REVISION TRANSMITTAL

LANDING GEAR - INSTALLATION OF THE NOSE LANDING GEAR TRUNNION SUPPORT ASSEMBLY
SERIAL PLACARDS

700 (Citation Longitude)

SB700-32-01
Page 1 of 4

Figure 1. Placard Installation (Sheet 1)

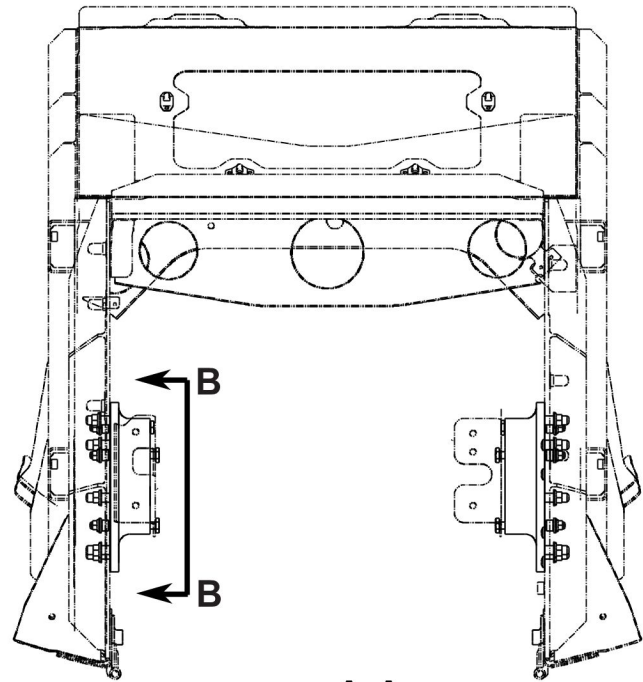
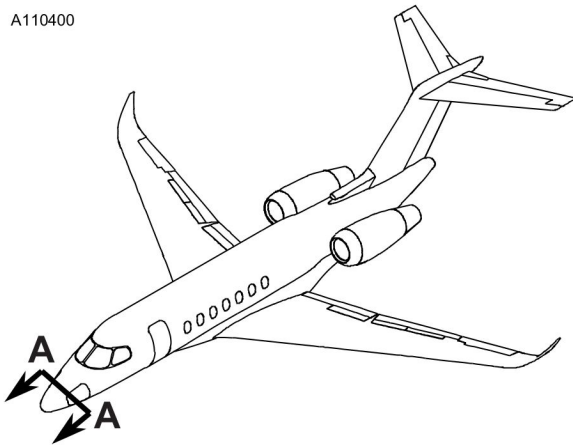
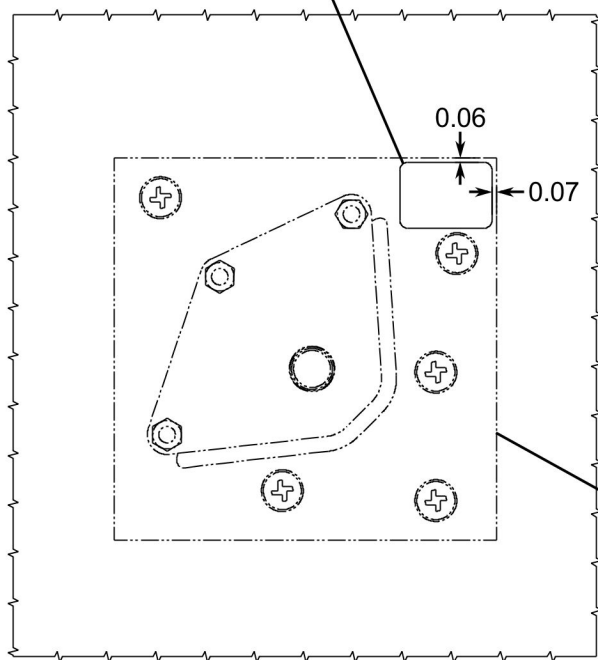
- C. 7413215-4 in the part number block for the right side.
 - D. TRUNNION SUPPORT ASSEMBLY" in the part name block.
3. (Refer to Figure 1, Sheet 1.) Install the S4515-4 Placards on the 7413215 Trunnion Support Assemblies with U470637, Type I, Class B Adhesive. (Refer to the Citation Standard Practices Manual, Chapter 20, Adhesive and Solvent Bonding - Maintenance Practices.)

S4515-4
Placard
(1 Required)

7413215
Trunnion Support Assembly
(Reference)

Left Side Shown, Right Side Opposite.
